APPLICATION TO BOARD OF ADJUSTMENT
GENERAL VARIANCE/PARKING VARIANCE

Variance to section 25-2-492(D) to allow 3' encroachment into street side yard.

CASE#: C15-2010-0116

LOCATION: 3112 WHITE ROCK DR

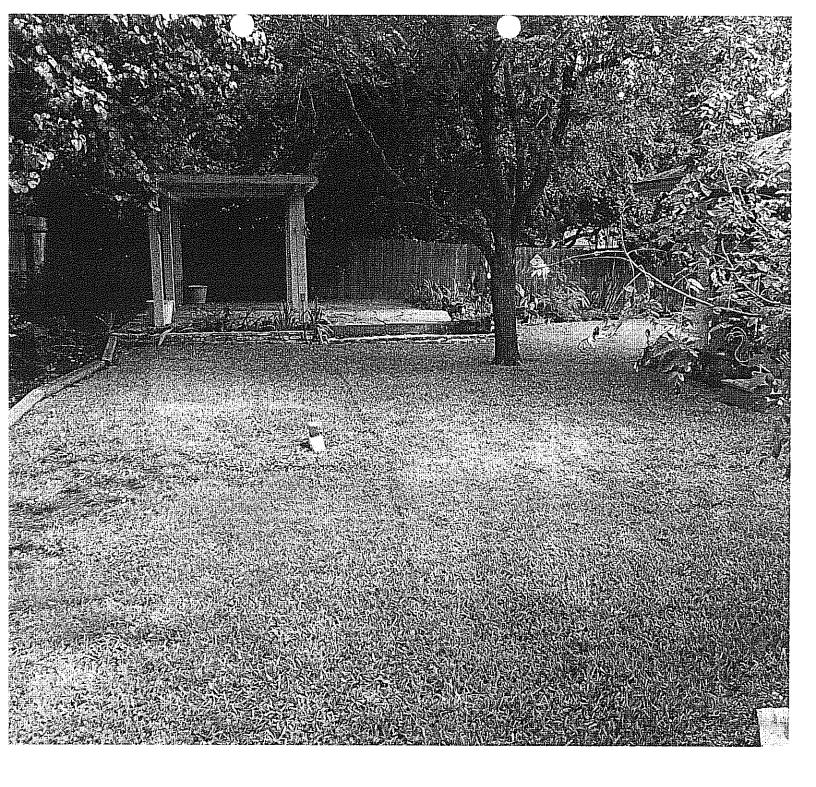
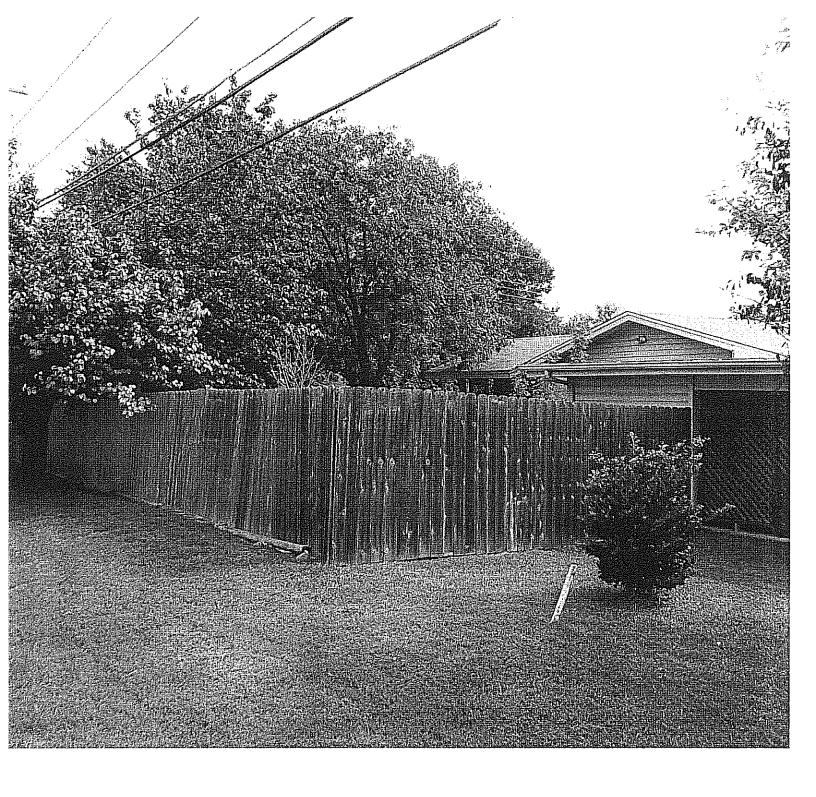
David, the non-preferred location would not be approved unless the Service Drop location was changed. The preferred location appears to look like we would approve it without any problems.

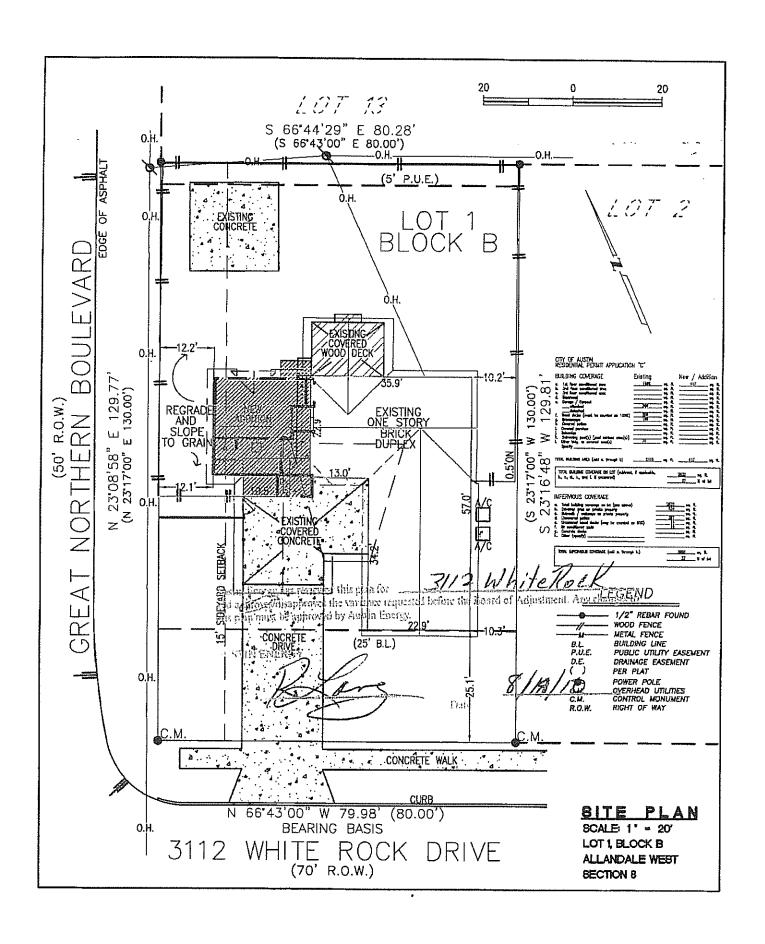
Austin Energy (AE) has reviewed your application for the above referenced property requesting to reduce the west side yard setback from 15 ft to 12 ft in order to erect an addition. Austin Energy has no conflicts with this application as requested and shown on the attached red-stamped sketch.
